SERVICE LETTER 00072

Date Released:	June 19, 2023
Date Effective:	June 19, 2023
Subject:	Ignition Module Firmware Update
Affected Models:	RV-12iS with avionics kits shipped before June 2023 RV-12iS SLSA Serial Numbers 12003, 12076-12128
Required Action:	Install new ES-60016-7.3 microcontroller on AV-60007 Ignition Module
Time of Compliance:	Optional, upon indication of below-described start behavior
Supersedes Notice:	N/A (if applicable)
Labor Required / SLSA Warranty Allowance:	0.5 hours
Level of Certification:	SLSA: LSA Repairman Maintenance or A&P ELSA: Owner (certification not required) <i>Check the rules of the local controlling authority/agency and the operating limitations for your aircraft.</i>

FIGURE 1: AV-60007 IGNITION MODULE

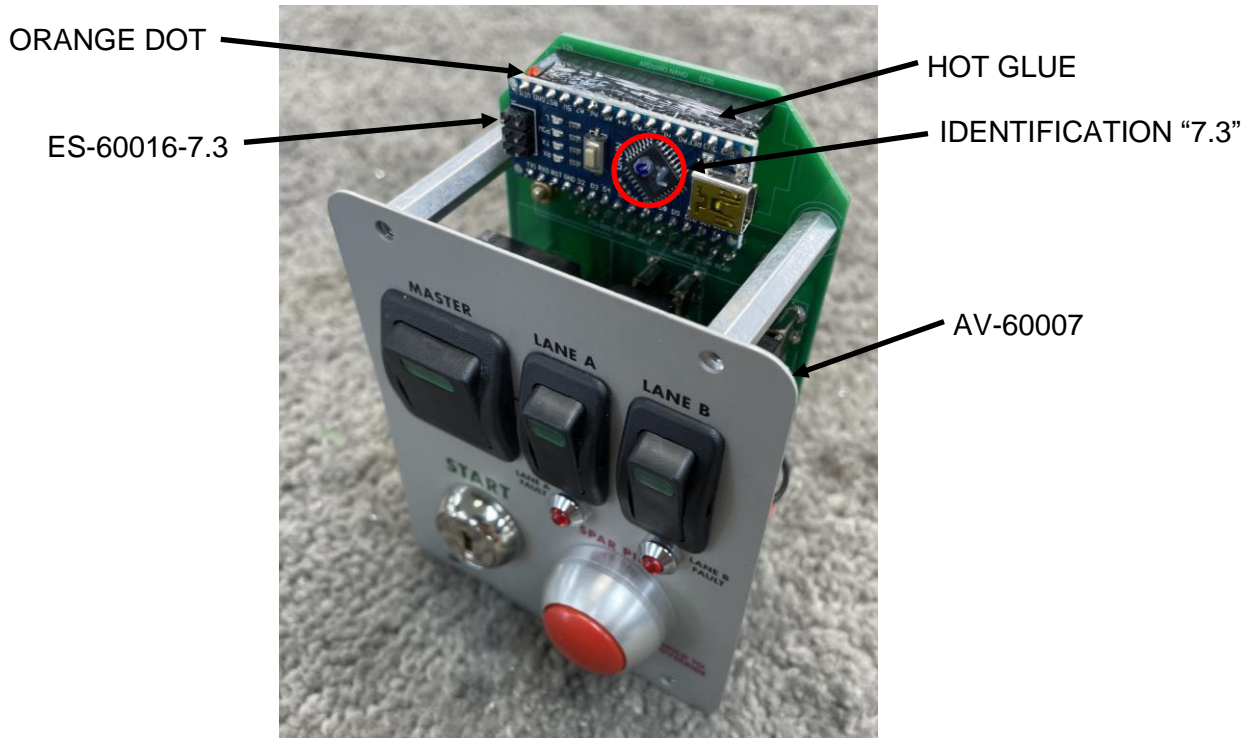
Step 3: Remove the ES-60016 microcontroller from the AV-60007 Ignition Module. See Figure 1.

Step 4: Install the ES-60016-7.3 microcontroller on the AV-60007 Ignition Module with the orange dot facing up. See Figure 1.

NOTE: The ES-60016-7.3 can be identified by “7.3” written on the microcontroller chip, as shown in Figure 1.

Step 5: Apply a strip of hot glue across the top of the ES-60016-7.3 and AV-60007 as shown in Figure 1. The hot glue must bridge across both components to retain the ES-60016-7.3.
